From: Swenson, Daniel P SPL [Daniel.P.Swenson@usace.army.mil]
Sent: 7/18/2014 11:47:08 PM
To: Allen, Aaron O SPL [Aaron.O.Allen@usace.army.mil]; Pankratz, Shannon L SPL [Shannon.L.Pankratz@usace.army.mil]; McGuffie, Brianne E SPL [Brianne.E.McGuffie@usace.army.mil]
CC: Amato, Paul [Amato.Paul@epa.gov]; Troxel, Tiffany A SPL [Tiffany.A.Troxel@usace.army.mil]
Subject: Peterson Ranch > Dan's review of sponsor's response to comments letter (6/4/2014) and 7/15/2014 IRT submittals re: proposed SA (UNCLASSIFIED)
Attachments: Ecoregions_SoCal_Omernik Level IV_8.gif; Ecoregions_SoCal_Omernik Level IV_85.gif; Peterson Ranch bank_service area_v02_L4 ecoregions_v02.pdf

My review of sponsor's response to comments letter (6/4/2014):

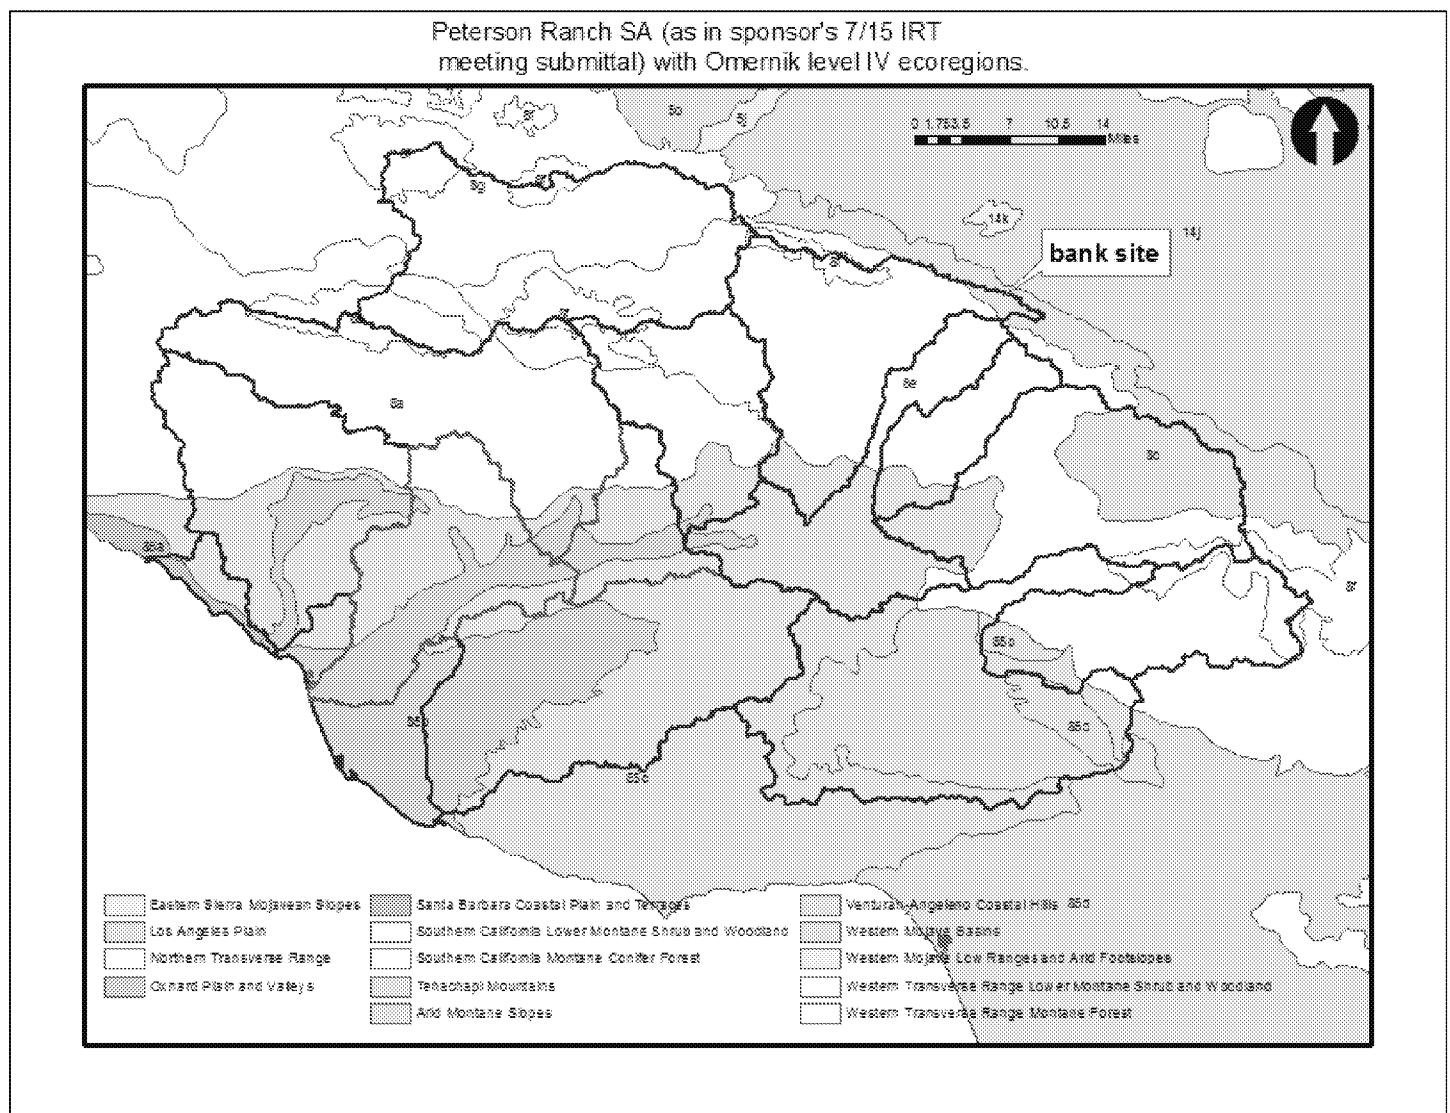
*****The new SA map doesn't show all the Omernik Level IV (most detailed) ecoregions, So I created a map that does (below and attached). For example, the bank site appears to be within or near 8c (Arid Montane Slopes) and/or possibly 8e (SoCal lower montane shrub and woodland). The current proposed SA (primary = red, secondary = blue, tertiary = purple) shows that level IV ecoregion varies quite a bit within the proposed service area. Although I'm not that familiar with these ecoregions, it seems some of these are substantially different from those of the bank site itself. We should consider whether all these should be in the SA. For example, the upper LA HUC is mostly Los Angeles Plain (probably very different) whereas the Big Tujunga Creek HUC is mostly SoCal lower montane shrub and woodland which is contained by or at least near the bank site. The Sespe Creek HUC, the northern part of the Upper Piru Creek and Ventura River HUCs, and the coastal HUCs are also different in terms of ecoregion. This may be a case for reducing the currently proposed SA. [please note:**

the attached ecoregion gifs show the codes together with text names, but the colors do not match my map below]
